Technical Service Bulletin (TSB)
Flash: Motor Control Processor B (MCP B) Updates 11A1

REFERENCE:	TSB: 08-013-25 REV. B GROUP: 08 - Electrical	Date:	April 29, 2025	REVISION:	08-013-25 REV. A
VEHICLES AFFECTED:	2024 (KM) Jeep Wagoneer S This bulletin applies to vehicles equipped with 400V G2500 FR/RR Elec Drive Motors (Sales Code ELD).			MARKET APPLICABILITY:	
				<input checked="" type="checkbox"/> NA	<input checked="" type="checkbox"/> MEA
				<input checked="" type="checkbox"/> **SA	<input checked="" type="checkbox"/> IAP
				<input checked="" type="checkbox"/> EE	<input checked="" type="checkbox"/> CH**
CUSTOMER SYMPTOM:	<p>Customers may experience a Malfunction Indicator Lamp (MIL) illumination and the vehicle may exhibit/set the following Diagnostic Trouble Code (DTC):</p> <ul style="list-style-type: none"> • P1626-00 - Park Pawl Motor Stuck. <p>Customers may also comment on one or more of the following:</p> <ul style="list-style-type: none"> • Wrench lamp on in the Instrument Panel Cluster (IPC). • Not able to move the shifter out of Park. • Vehicle has reduced power. <p>This bulletin also includes the following software enhancement:</p> <ul style="list-style-type: none"> •

Fig. 1
Cooling Fan Assembly

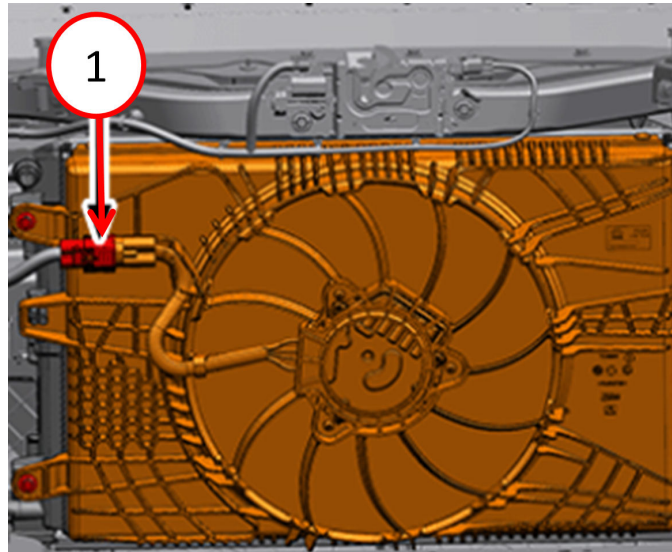
4. Disconnect the cooling fan wire harness connector [Fig. 1](#).**

22. **Connect the cooling fan wire harness connector [Fig. 1](#).
